**18/02070/FUL**

**Windyridge  
Station Road  
Stow-On-The-Wold  
Gloucestershire  
GL54 1JU**

**Erection of a single dwelling house, detached garage and associated works, formation of a new access and erection of a garage to serve Windy Ridge (Amendments to size and design of dwelling approved under permission 16/03900/FUL) at Windyridge Station Road Stow-On-The-Wold Glos GL54 1JU**

<b>Full Application 18/02070/FUL</b>	
Applicant:	Derek Morris
Agent:	
Case Officer:	Martin Perks
Ward Member(s):	Councillor Dilys Neill
Committee Date:	8th August 2018
<b>RECOMMENDATION:</b>	<b>PERMIT</b>

**Proposed Elevations - North East and North West**

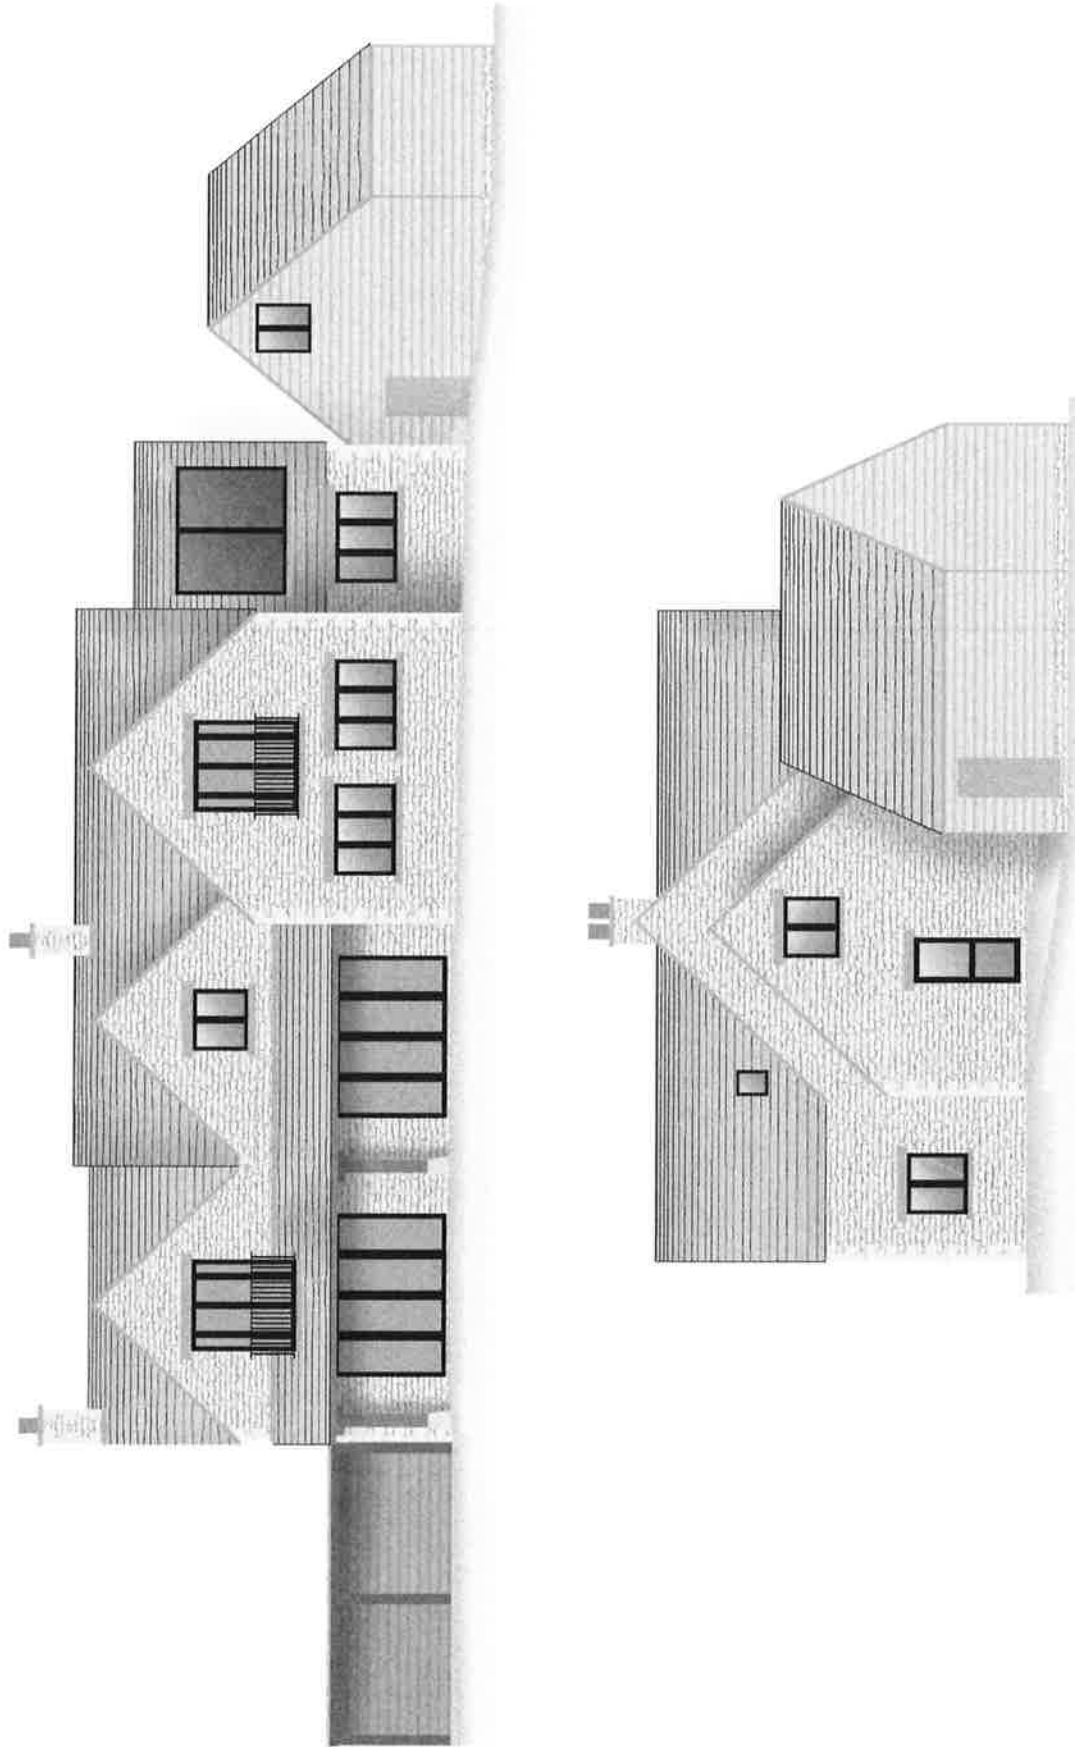
1. The level of the site has been elevated with landfill so that it is now one and a half metres above the level on the original plan. The eaves height is not mentioned on the new plans but overall the house stands higher than agreed.

- x) The house has not been constructed in accordance with a previously granted permission in a number of ways. It stands considerably higher than originally planned and as a result acts as an unsightly blot on the skyline when approaching the town from the Lower Swell and the west.

The comments of Stow Town Council and neighbours regarding the height of the dwelling are noted. However, the submitted plans show the height, proportions and levels of the proposed development as being the same as that approved in 2016. The previous scheme allowed site levels to be changed as part of the development and the completed works appear consistent with those previously agreed. No evidence has been provided to demonstrate that the building constructed is 1.5m higher than that approved previously. Notwithstanding this, the development now submitted has to be assessed on its own merits. Even if it were larger than the scheme approved in 2016, it would not automatically mean that the development is unacceptable. The development under construction still has to be assessed against policy, guidance and other material considerations. In this instance, the dwelling is set back approximately 50m from the A429 and is set down below the level of the road. The neighbouring dwelling (Four Gables) to the south is located on ground which is approximately 2m higher than the application site. The aforementioned dwelling is noticeably higher than the dwelling at Windy Ridge. The dwelling does not appear incongruous, obtrusive or disproportionately large. It also does not appear out of character with the existing pattern of development evident along the western side of the A429 as you approach the town from the south. The development is considered not to have an adverse impact on the character and appearance of the area.

**Proposed Elevations - South West and South East**

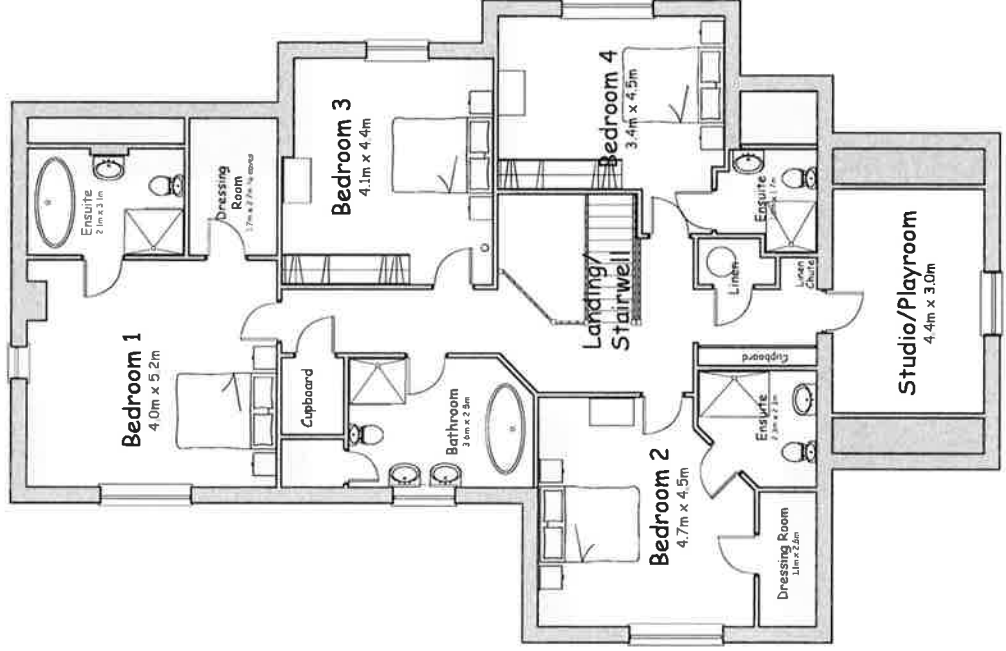
3. The design of the windows has changed, and they look a lot bigger. There is also a first floor window on the south side which wasn't on the original plan. This overlooks the neighbours.

- vii) On this set of amended plans, to accompany this retrospective application, a window has been added, and already constructed. It directly overlooks my garden and conservatory, and was not on the previous set of plans. It is highly intrusive and denies me privacy in my garden and my house.

- xi) Additional fenestration has been added on the southern elevation which intrudes on both my neighbour's and my gardens and one of my bedrooms. Prior to making the original planning application a large number of trees were removed on the site. Regrettably none of these trees had TPOs. Had the trees not been removed they would have helped but not solved the lack of

The main change to the approved scheme, insofar as privacy and amenity are concerned, is the installation of a first floor window in the southern gable elevation of the dwelling. The new window is positioned in a 1.5 storey high extension and serves a play room. The window is located approximately 21m from the southern boundary of the application site. The southern boundary adjoins the side boundary of a residential dwelling (Four Gables). Four Gables lies side on to the application site. Its front elevation faces west towards the A429. Its northernmost side elevation is located approximately 9m from the application site boundary and approximately 30m from the window in the southern gable elevation of the new dwelling. In addition, Four Gables and its rear garden are elevated approximately 2m above the application site. A 1.8m high timber close boarded fence also extends along the side boundary of Four Gables.

The window in the southern elevation of the new dwelling is located approximately 30m from windows in the rear elevation of Four Gables. The respective windows also lie at an oblique angle to the application site. It is considered that, by virtue of distance and the obliqueness, that the new dwelling will not have an unacceptable impact on the privacy of habitable rooms within Four Gables. With regard to the conservatory to the rear of Four Gables, the aforementioned development is located in excess of 22m from the window in question and is therefore beyond the 22m distance specified in the Design Code. It would not therefore be possible to sustain an

objection to the window in the southern elevation with regard to its impact on the neighbour's conservatory.

PROPOSED GARAGE ELEVATIONS 1:100  
(Swell View)

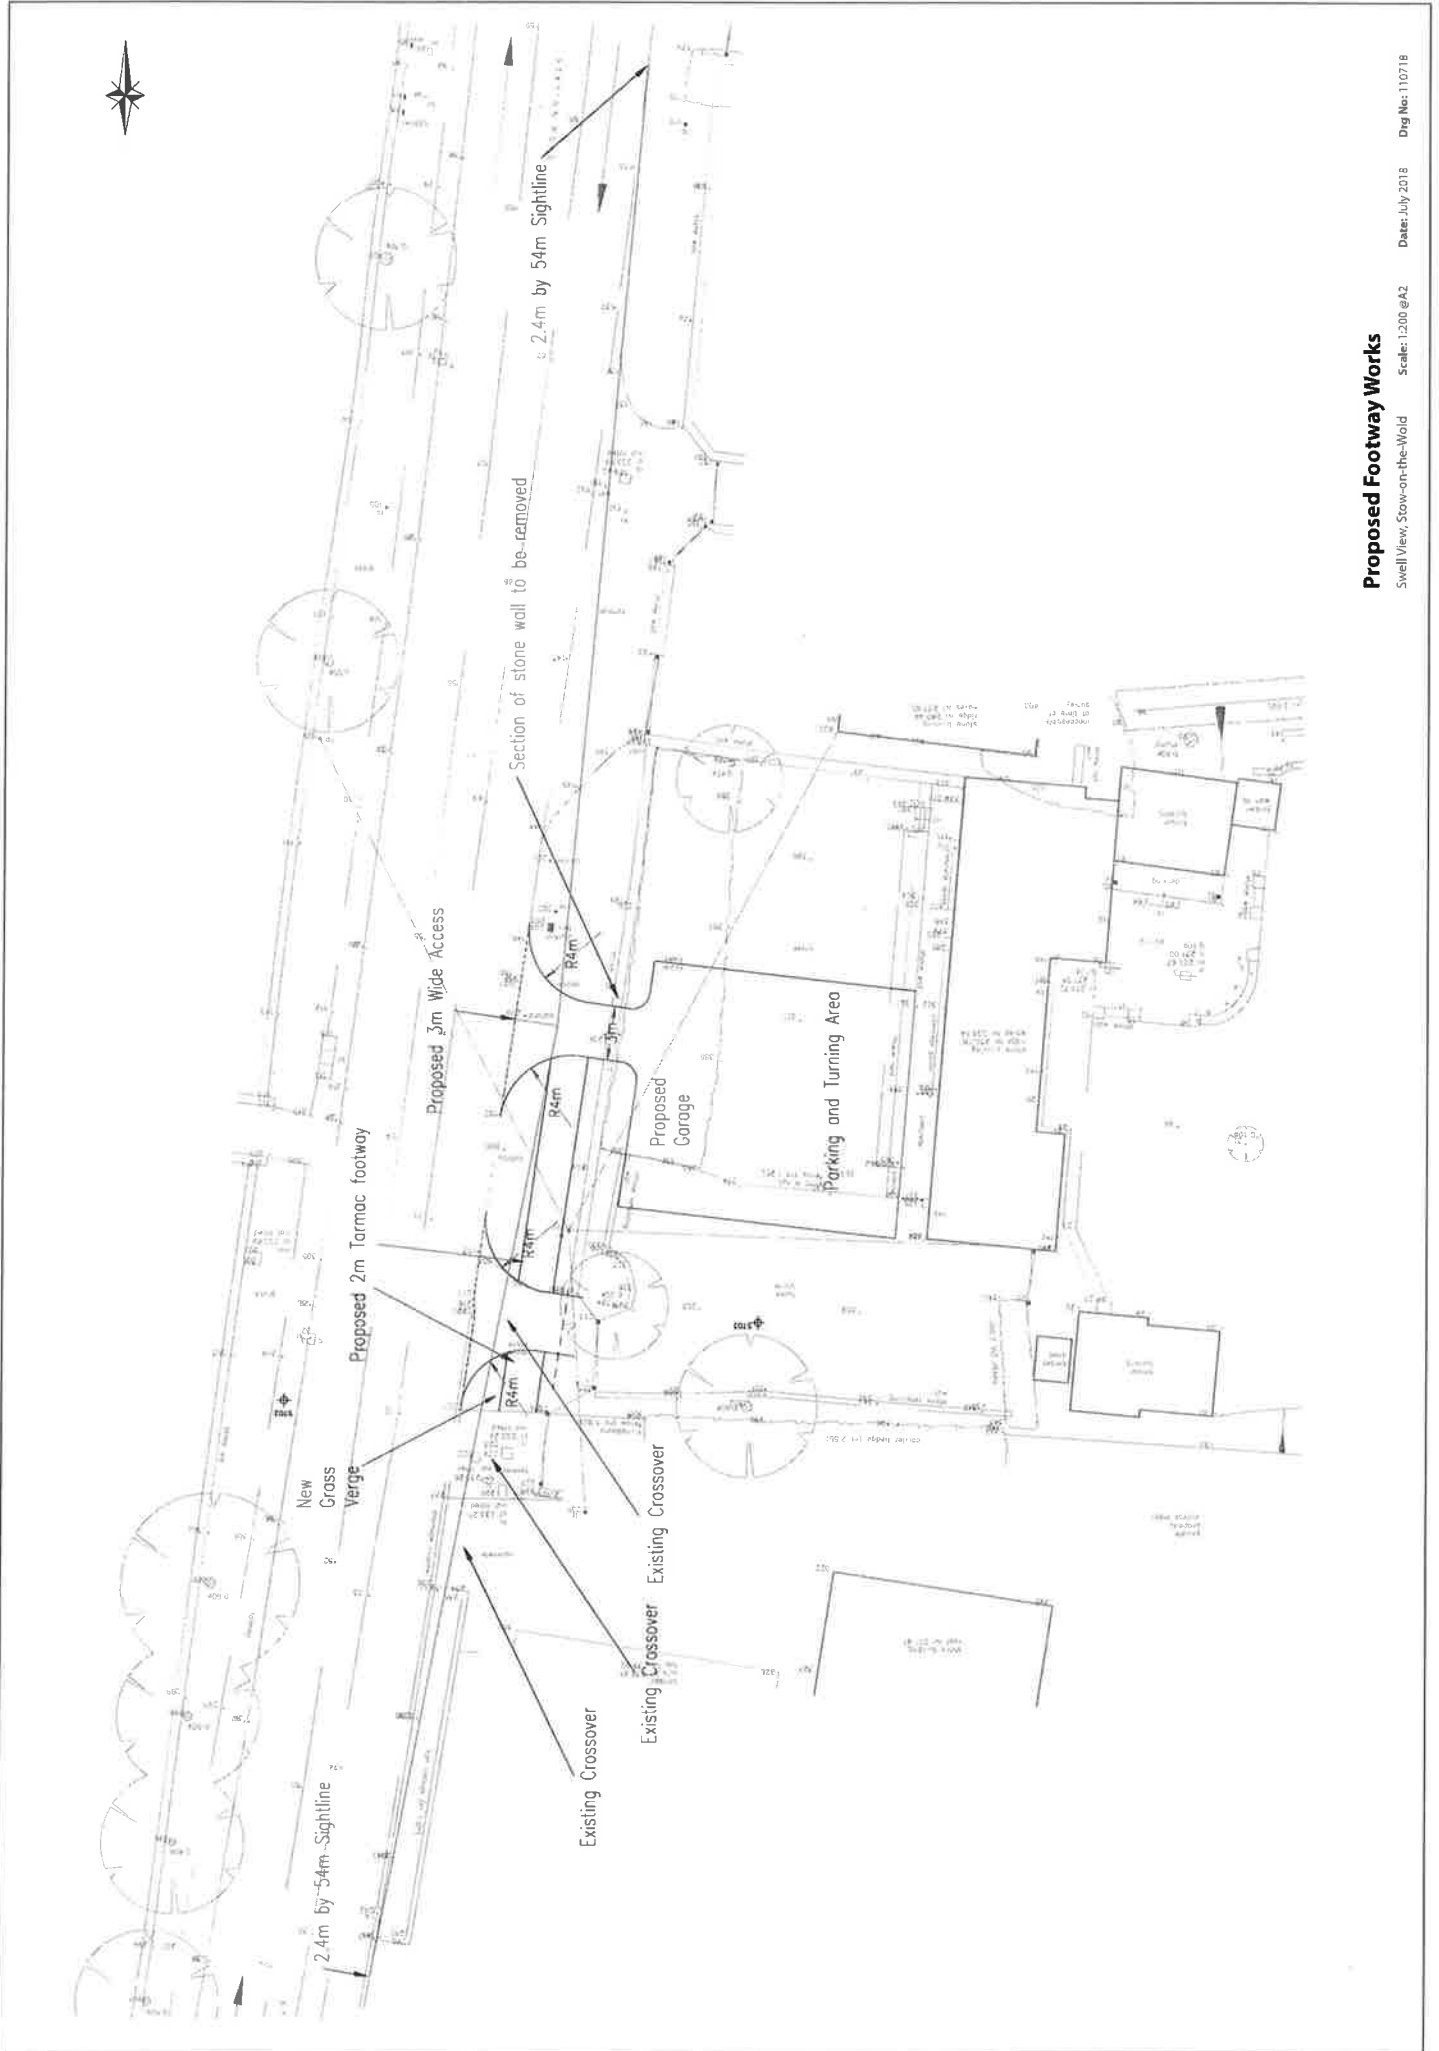
2. The garage on the original application is single story. Although on the planning portal it is still shown as single story, I have been told that it is intended to put in an upper floor, as on some drawings I have seen there is an upstairs window.

**Proposed Footway Works**

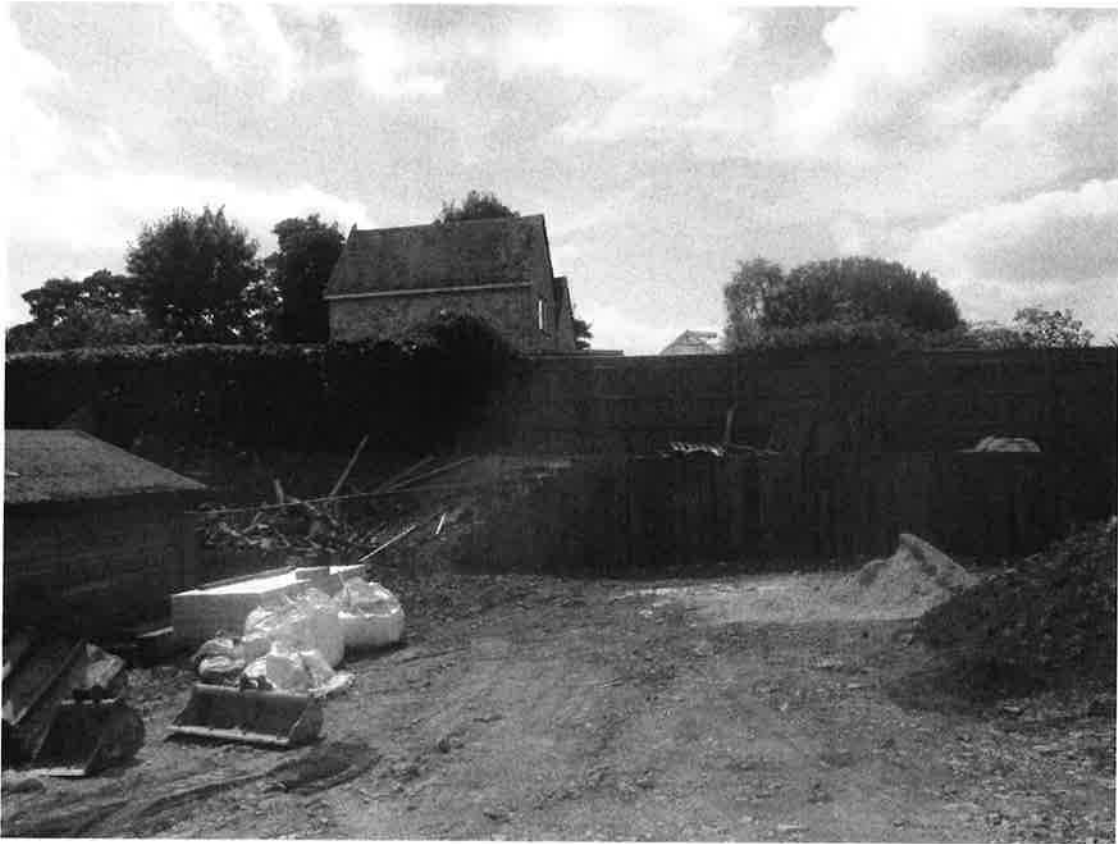
The path at the front of the property to be installed as per 2016, has not been constructed.

The schemes previously approved granted permission for the creation of a new vehicular access from the front (east) of Windy Ridge onto the A429 and for improvements to an existing driveway lying to the side (north) of the aforementioned dwelling. The applicant has completed the new access onto the A429. With regard to the existing driveway entrance, the applicant is proposing to upgrade the entrance and to introduce a 2m wide tarmac footway in a grass verge lying between the front of the application site and the A429. The footway will be set back approximately 2m from the carriageway of the A429. The footway will provide future residents of Windy Ridge and the new dwelling with a dedicated pedestrian access to existing hard surfaced areas to the north. The new footway is considered to represent a betterment in highway safety terms.

Prior to the first occupation of the dwelling hereby approved the footway adjacent to the A429 shall be completed fully in accordance with drawing 110718 and retained as such until adopted as highway maintainable at the public expense
